# SERVICE BULLETIN

AIRCOOLED MOTORS INC.  
SYRACUSE 8, NEW YORK

NO. B-99

**SUBJECT:** CONNECTING ROD MODIFICATION

FIGURE 1

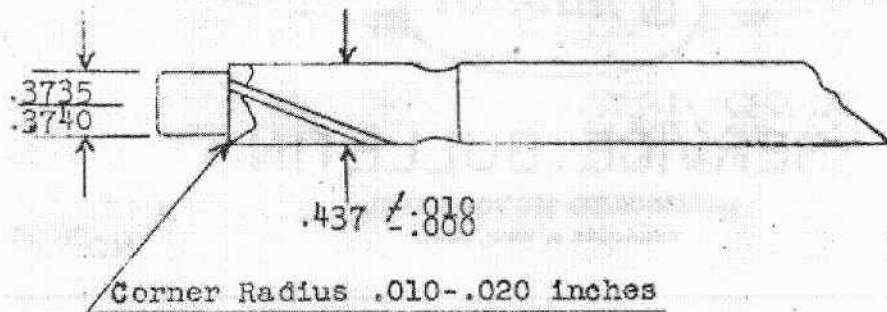
- a. The modification of connecting rods affected by this change order shall be accomplished as follows:
  1. Procure a piloted countersere tool similar to that shown in Figure

FIGURE 2

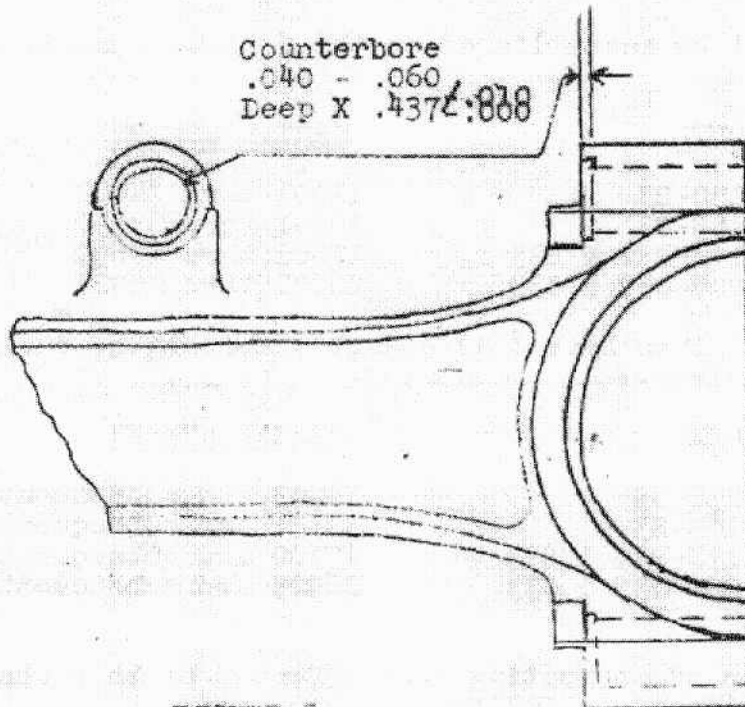
2. Counterbore the blade half of the connecting rod at the bolt head end of both bolt holes to a diameter of  $.437 \pm .010$  inches and depth of .040-.060 inch in accordance with Figure 2.
